## Initial Project Review

### Major Amendment to Approved Preliminary Plat / Planned Development District / Environmental Review:

#### Nicolina Meadows PDD

**Application Numbers: 915704 / 915723 / 915707**

# Major Amendment/PDD Site Plan

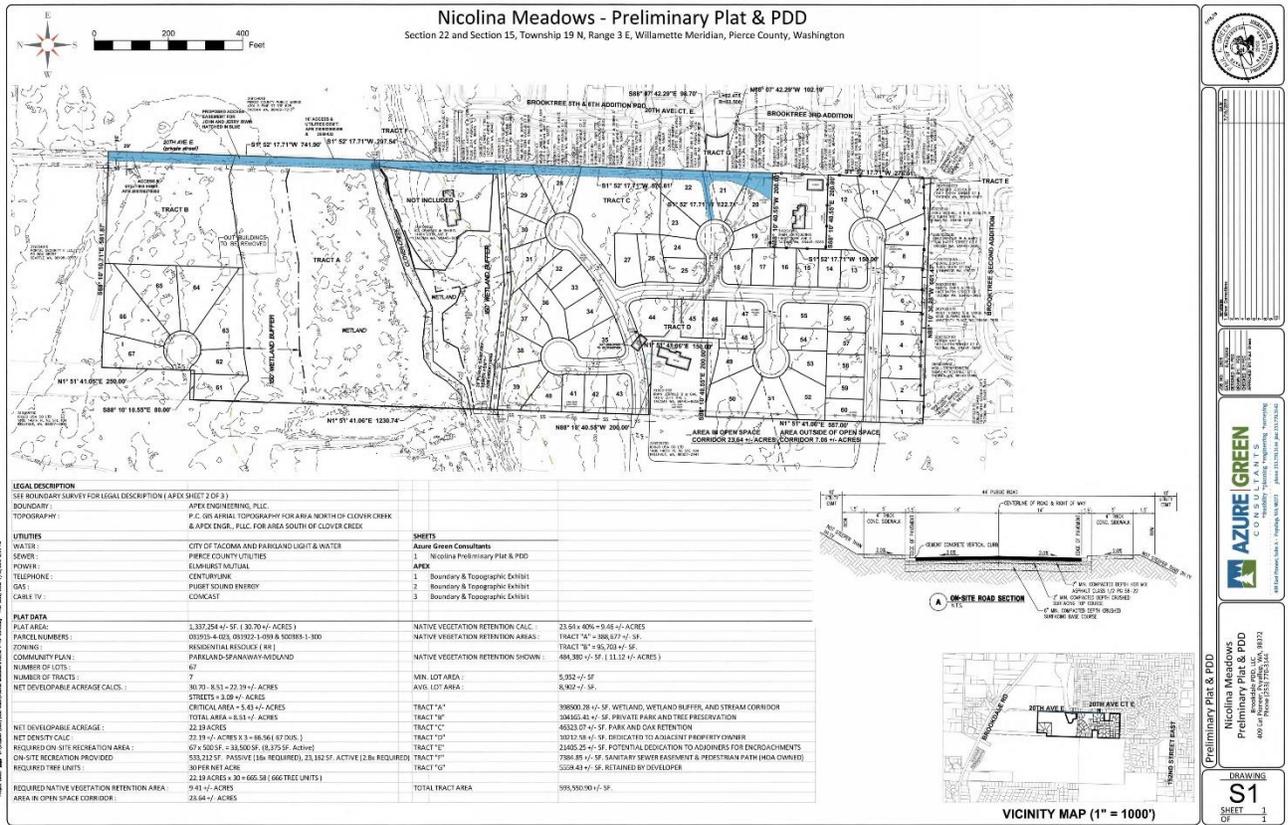
- Planned Development District (PDD) – The original preliminary plat approval was for 62 single-family lots. A PDD was not required at that time. In exchange for an additional five single-family lots and to reduce interior yard setbacks from 10 feet to five feet, the applicant is proposing to develop a 1.06-acre park Tract C in the southern end of the plat for active and passive recreation and a 2.39-acre passive recreation Tract B in the northeast corner of the plat. Both tracts will also provide for Oregon white oak tree preservation.

The number of lots in the southern portion of the plat are being decreased from 62 to 60. The majority of the 7 lots proposed in the northwest corner of the plat will be significantly larger than the lots in the southern portion of the plat. The applicant states that the PDD approval will have a beneficial effect on the area by providing lots that are similar in size or larger than surrounding areas and significant open space is being provided.

- Street trees will be provided at a minimum of 1 street tree per lot will be required prior to home occupancy and street trees at 1 per 30 lineal feet along the frontage of park Tract C.
- Curbs, gutters, sidewalks and street lights will be required within the plat.
- In addition to on-site recreational improvements, park impact fees, currently \$2,552.39 per dwelling unit, to be adjusted upward for inflation are required prior to building permit issuance.
- The RR zone requires that 30 tree units per net acre, respectively, be preserved and/or planted, i.e., 665 tree units on 22.17 net acres. The original approvals retained 690 tree units (274 trees). The applicant has not indicated how many tree units and trees the modified Major Amendment proposal will retain.

- As part of the review of original proposal, the original applicant's arborist, Washington Forestry Consultants, Inc. (WFCI), identified 105 Oregon white oak trees on this 30.70-acre site. Of these trees, 32 oak trees with 8 inches or greater DBH (30% of 105) were required to be retained. Twenty-seven of the significant oaks are located north of Clover Creek in original Tract I. Ninety percent of the 20 inches DBH or greater oaks are located north of Clover Creek - this satisfies the 70% retention in 18E.40.040. In the original proposal, WFCI identified 14 additional significant oaks to be retained south of Clover Creek in Tract C for a total of 37. Nine additional oaks less than 8 inches DBH were also located in original Tract "C". It is unclear how many significant oaks will be preserved in the portion of proposed Tracts A, B and C.

WCFI determined that there are 295 significant Douglas fir trees, 23 significant western red cedar trees, and 1 significant Sitka spruce tree. The applicant is required to preserve a minimum of 10% of these trees, i.e., 32 trees. Tree Conservation Plans are required to attempt to meet the tree unit requirement, i.e., 665 tree units, by first preserving as many trees as feasible. In his October 15, 2010, letter and table, Galen Wright of WFCI demonstrated that the original applicant would preserve 274 trees and 690 tree units in plat tracts. In an October 2010 table, Mr. Wright also indicated that 66 non-oak significant trees would be retained. An additional 126 other non-oak trees would be preserved in original Tracts A and I. It is unclear how many non-oak trees will be preserved in the portion of proposed Tracts A, B and C.

The proposed passive recreation Tract B is similar in size and location to original tree retention Tract I. The proposed wetland and stream corridor Tract A is similar in size and location to original wetland and stream corridor Tract A. The proposed active and passive recreation Tract C is similar in size and shape to original tree retention Tract C.
